# Silicon Anomaly Sheet

AD1837

This document details known bugs in the current version of the AD1837.

Figure 4. Reset Synchronized to Rising Edge of FSTDM/ALRCLK

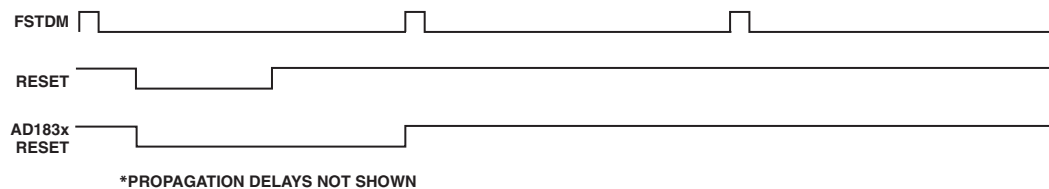
The ADC engine used in the AD1837 loads the serial port with the results of the last conversion periodically at the sample rate. The loading operation is initially determined by where the  $\overline{PD/RST}$  pin goes high. For slave mode operation, the LRCLK or FSTDM signal have no fixed relationship so it is possible that the loading operation can occur in the middle of a data transfer. This results in the right ADC sample being one sample ahead of the left ADC sample, which presents itself as a phase shift. See Figure 1.

Synchronizing the rising edge of  $\overline{PD/RST}$  with the appropriate LRCLK (for I<sup>2</sup>S, left or right justified modes) or FSTDM (for TDM256 mode) edge will ensure that the ADC result updates occur in a safe region and the phase shift will not occur. Figure 2 shows a synchronization circuit using a single flip-flop that latches the reset signal on the rising edge of FSTDM/ALRCLK. Figure 3 shows an alternate circuit for latching the reset on the falling edge of ALRCLK. Figure 4 shows a timing diagram associated with Figure 2. Table I lists the ADC modes affected by this issue and which circuit should be used to prevent it occurring.
